**RE: MP 07_0010 – Environmental Assessment for Concept Plan and
Stage 1 Project Application
Lot 4 DP 615261, Lot 1 DP 374315 and Part Crown Reserves R.82555 +
R.754444, Ocean Drive Lake Cathie**

**RE: MP 07_0010 - ENVIRONMENTAL ASSESSMENT FOR CONCEPT PLAN AND
STAGE 1 PROJECT APPLICATION
LOT 4 DP 615261, LOT 1 DP 374315 AND PART CROWN RESERVES
R.82555 & R.754444, OCEAN DRIVE, LAKE CATHIE**

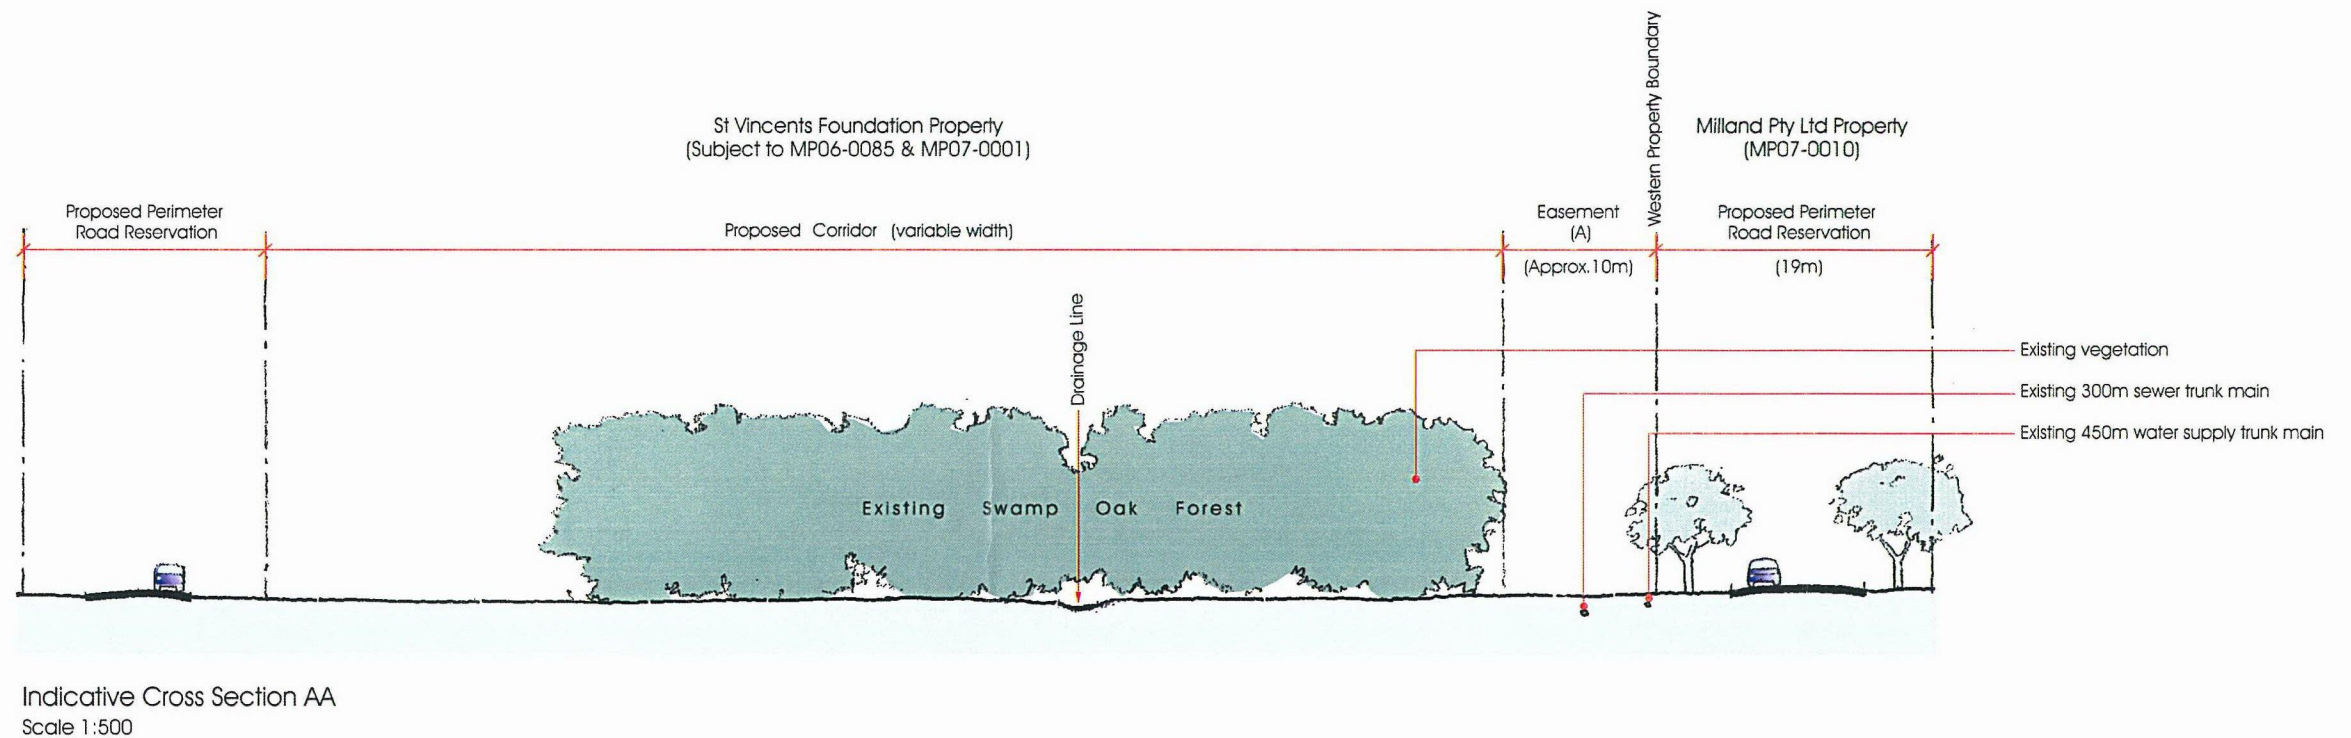
- Copy of the Plan (**Exhibit 06E rev.C**) and Cross-Section (**Exhibit 06F rev.B**) of the proposed Western boundary edge treatment adjoining the existing easement and swamp oak forest on the adjoining SVF land that were forwarded to Biolink Pty Ltd on 29 April, 2011.

- Biolink agree with PMHC that the Water Supply and Sewerage Easement approximately 9m wide effectively undermine the merit of an ecological buffer to the swamp oak forest;

- Biolink's preference is that from the western edge of the easement and for a distance of some metres into the swamp oak forest, dense plantings of *Lomandra* and *Gahnia* are established;

- Amended **Exhibit O8A rev.G** – 'Stormwater Concept Plan'; and
- New **Exhibit 06E rev.C** and **Exhibit 06F rev.B** in relation to the western boundary edge treatment.

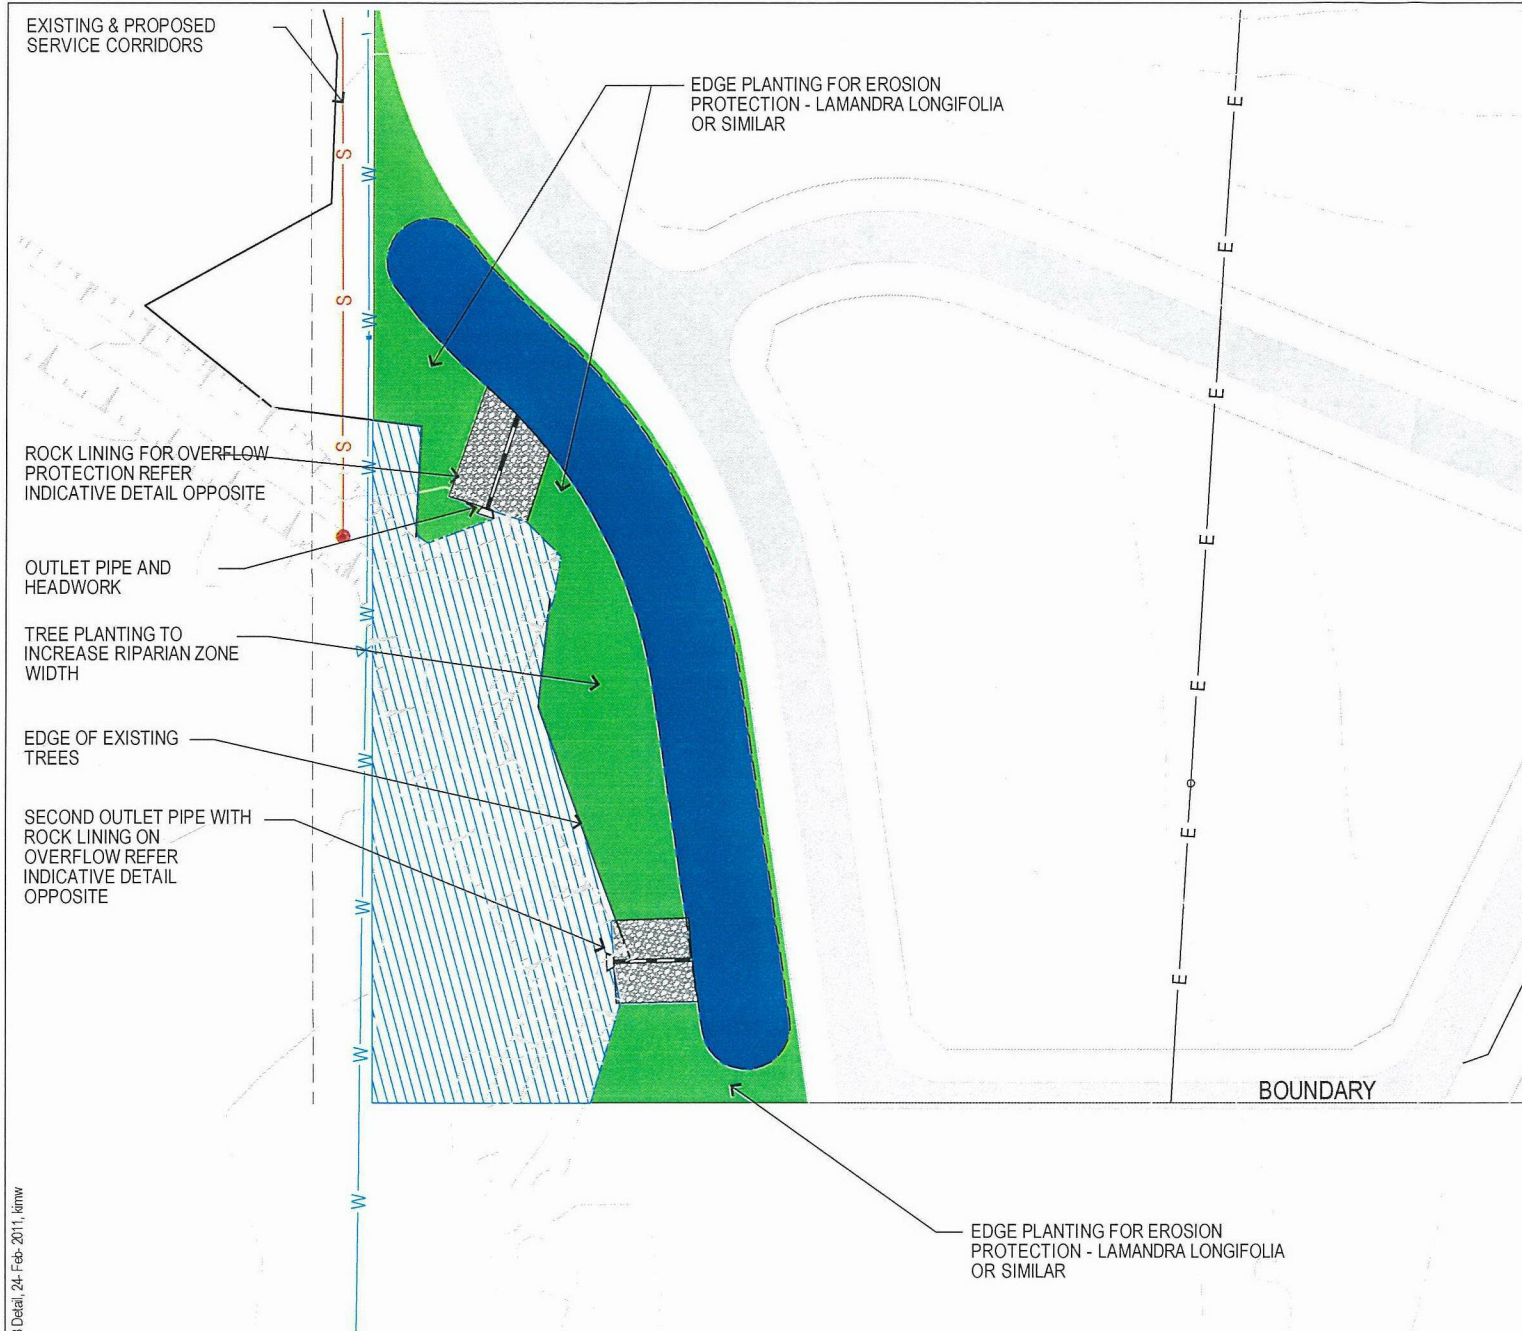
The project was modelled using MUSIC (Model for Urban Stormwater Improvement Conceptualisation) and the graphical representation of the MUSIC model (as included in the Environmental Assessment) is attached here for clarity (**Exhibit 08C, rev.C**). The Stormwater Concept Plan (**Exhibit 08A, rev.G**) has also been included to show the catchments, the detention and biofiltration locations and to correct an error in the north-western (NW) biofiltration basin. The biofiltration area for the NW catchment shown on Exhibit 08A has been amended to 1500m², and will be located within the stormwater detention basin. The overall footprint of the stormwater facilities in this location has not changed, nor has the data within MUSIC or DRAINS models.
